Contract No. T201507407.01
Federal Aid Project No. BHN-N056(43)
BR 1-717 On I-95 NB Over SR1
New Castle County

Enclosed is Addendum No. 1 for the referenced contract consisting of the following:

Addendum No. 1
February 4, 2016

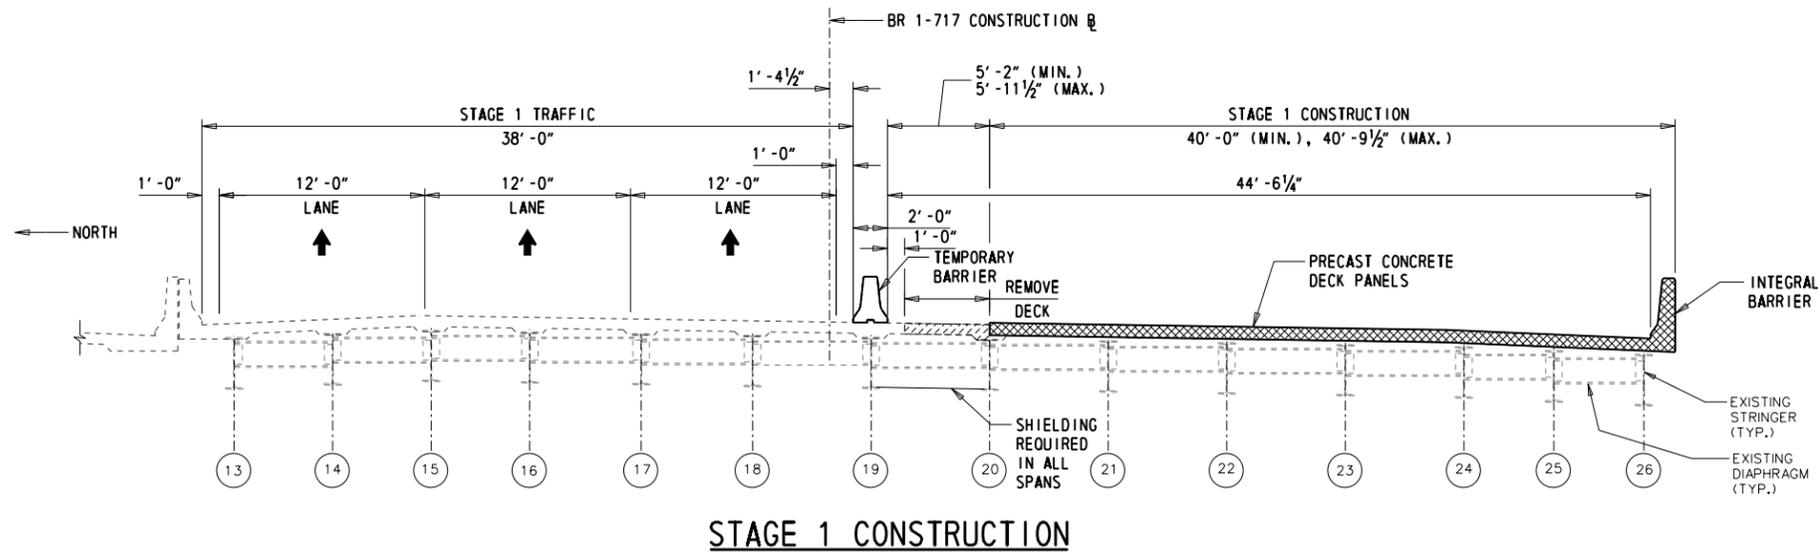
TIMBER SHIELDING CURRENTLY EXISTS BETWEEN STRINGERS 13 AND 24 IN SPANS M AND N. THE CONTRACTOR SHALL PROVIDE ADDITIONAL SHIELDING THROUGHOUT THE ENTIRE LENGTH OF THE BRIDGE UNDER THE BRIDGE MEDIAN, BETWEEN STRINGER 24 AND 26 AND ALONG THE SOUTH FASCIA AS WELL AS BETWEEN STRINGERS 13 AND 24 IN SPANS L AND P.

SHEET NO.	11
TOTAL SHTS.	64

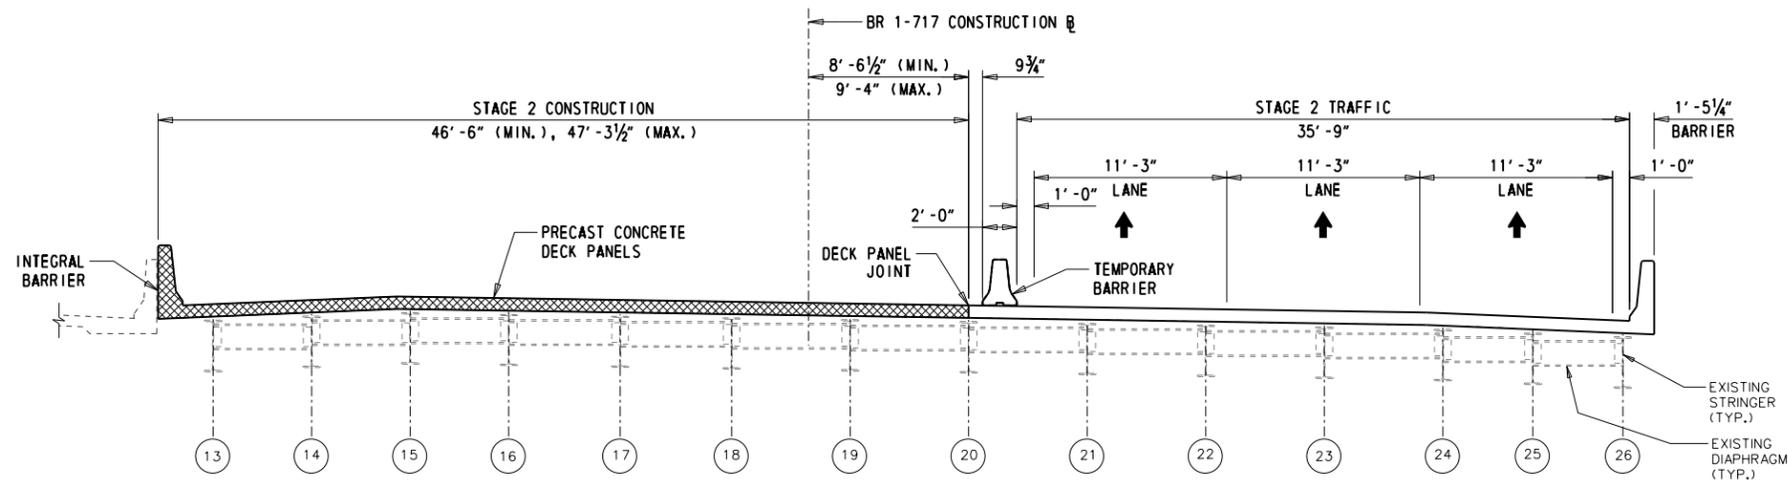
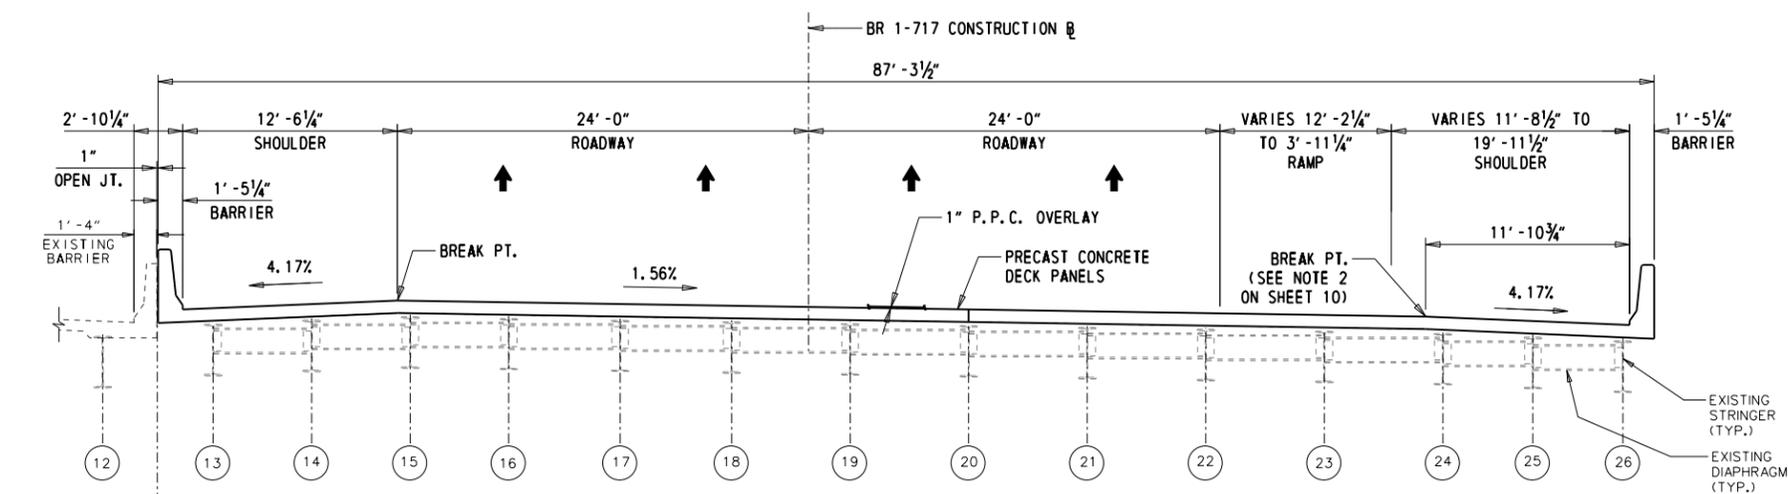
12. SET UP TRAFFIC CONTROL FOR STAGE 2 CONSTRUCTION IN ACCORDANCE WITH THE CONSTRUCTION PHASING, MAINTENANCE OF TRAFFIC STAGE 2 PLAN.
13. RELOCATE TEMPORARY BARRIER TO LOCATION SHOWN IN STAGE 2 CONSTRUCTION. STRUCTURE MOUNT TEMPORARY PCC BARRIER (STAGE 2 NORTHBOUND ONLY)
